**Rezoning Application: PD 26-0349**
**Zoning Hearing Master Date: March 23, 2026**
**BOCC Land Use Meeting Date: May 12, 2026**
**1.0 APPLICATION SUMMARY**

This is a request to rezone a site from a Planned Development (PD) to a new Planned Development in order to add approximately 13.1 acres into the project. The request also seeks to make some amendments to conditions implemented by the Transportation Department. The number of approved residential units will remain unchanged.

**AGENCY REVIEW COMMENT SHEET**

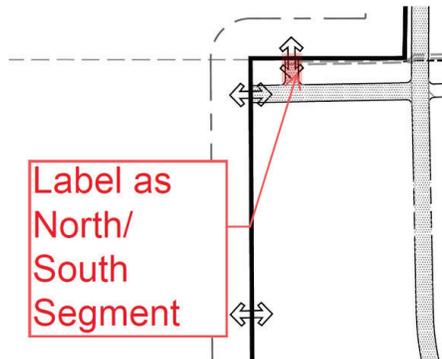
1. Prior to certification of the General Development Plan (GDP), the applicant shall revise the PD site plan to:
  - i. Modify the label reading “Proposed W. Lake Dr. Extension” to instead state “Proposed North/South Collector Road – See Conditions of Approval.”
  - ii. Remove the three internal access arrows along the Berry Grove Blvd. Ext. for consistency. Staff notes that not all connections are shown, and access will be subject to the LDC and conditions of approval.
  - iii. Label the section shown below as “East/West Segment – See Conditions of Approval.”

- iv. Label the section shown below as “North/South Segment – See Conditions of Approval”; and,

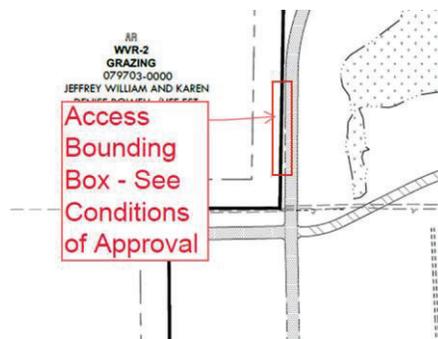
- v. Add a bounding box as shown below and label “Access Bounding Box – See Conditions of Approval” .

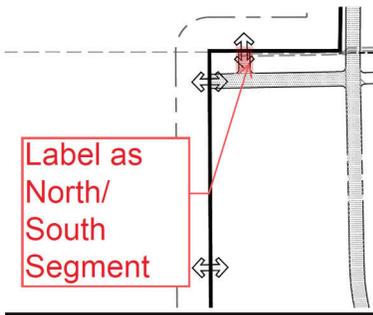
- Remove the three internal access arrows along the Berry Grove Blvd. Ext. for consistency. Staff notes that not all connections are shown, and access will be subject to the LDC and conditions of approval.
- Label the section shown below as “East/West Segment – See Conditions of Approval”

- Label the section shown below as “North/South Segment – See Conditions of Approval”; and,

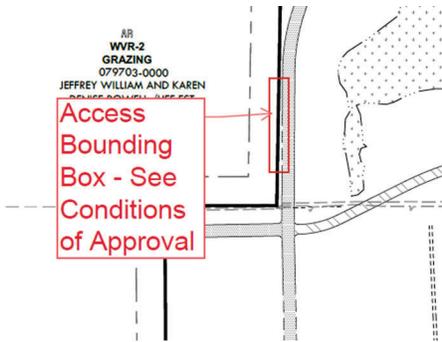
- Add a bounding box as shown below and label “Access Bounding Box – See Conditions of Approval” .
